V2500-A1/A5 SERIES PROPULSION SYSTEM SERVICE BULLETIN

This document transmits the Initial Issue of Service Bulletin EV2500-72-0429

ENGINE – LP COMPRESSOR – INTRODUCTION OF A SMALLER DIAMETER WASHER

Location of the Washer that connects the No.1 Bearing Support to the Fan Frame
Figure 1

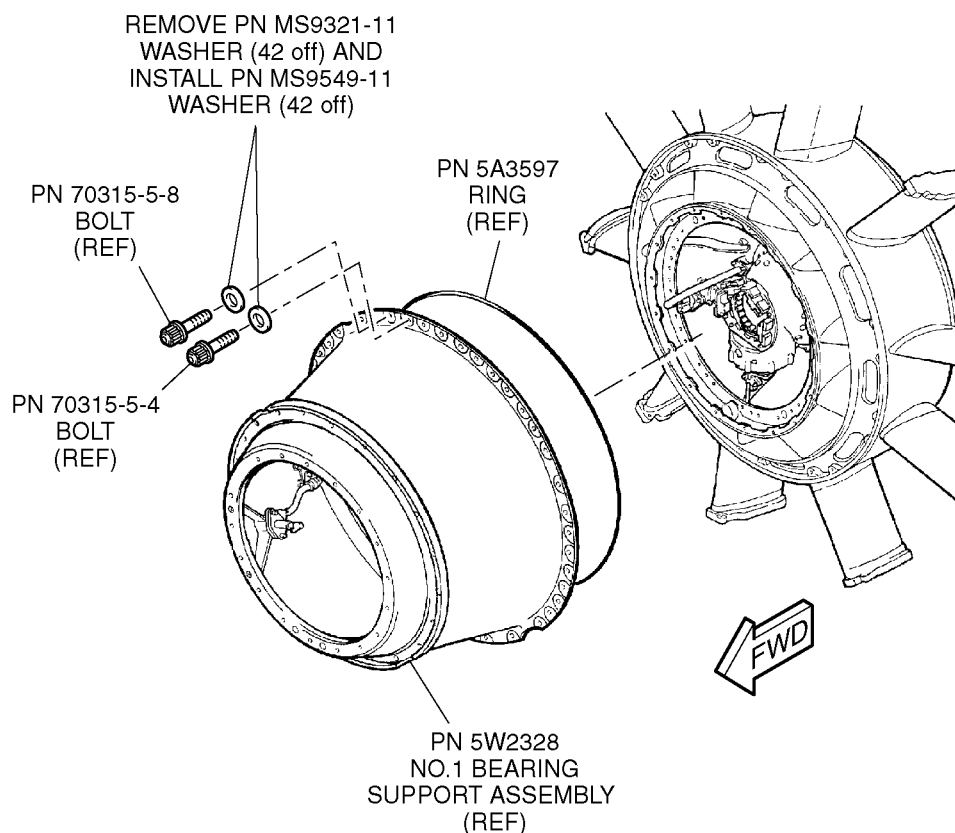
The washer MS9549-11 with smaller outer diameter will provide appropriate clearance to the counter bore instead of current washer MS9321-11.

The nominal outer diameter of washer has been changed from 0.625inch (15,875 mm) to 0.562inch (14,275 mm).

Install the new MS9549-11 washer (42 off) to the No.1 bearing support assembly by the procedure given in reference (1), Engine Manual (E-V2500-1IA), 72-32-00, Assembly-05

Family Tree - Washer for V2500-A1 and V2500-A5 Ref. Catalog Sequence No. 72-32-00
Fig. 02 Item 181
Figure 2

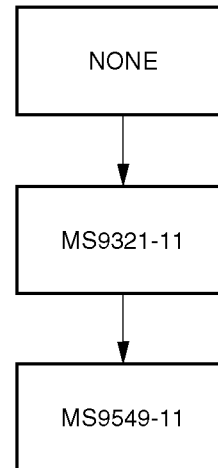
Introduction of the new washer
SBE 72-0429
